SANITARY WARE SPECIFICATION SHEET

**Approval of “AMERICAN STANDARD” Float Operated Valve
(General Acceptance No. C20221163F)**

Name of Manufacturer: Xiamen R&T Plumbing Technology Co Ltd
Country of Origin: the Mainland of China
Brand: American Standard
Details of Fitting: 5/8" Plastic float operated valve
Model: PC-A1260
Body Markings: Nil
Expiry Date: 26 April 2027

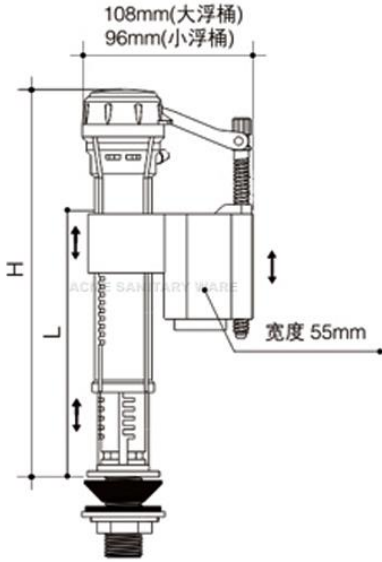
Having considered the test report ref. J27711 issued on 13 May 2022 by Nutek Systems (HK) Limited, this Authority accepts that the fitting described below complies with, and its use when correctly installed does not contravene, the Waterworks Ordinance and Regulations.

Proviso: As the fitting has not been tested for use in contact with water intended for human consumption, the fitting can only be used in flushing water plumbing systems.

This Authority hereby permits the use of the above fitting in flushing water plumbing systems subject to full adherence to Waterworks installation requirements. In particular, you are required to draw your customers' attention to the following requirement-

"The flushing volume of the flushing valve should be adjusted to suit the design of the toilet bowl so that wastes can be cleared effectively by a single flush."

"The fitting should be used within the range of working pressures specified by the manufacturer." AND

"The installed fitting should not result in backflow of water that will contaminate the flushing water supply."

A condition of this acceptance is that the fitting to be installed shall be replicas of the sample as certified by the testing agent mentioned above and without modifications. This acceptance may be withdrawn at any time if the standard of the fitting installed fails to meet that of the approved sample or if the fitting is found to be unsuitable for use in flushing water plumbing systems.
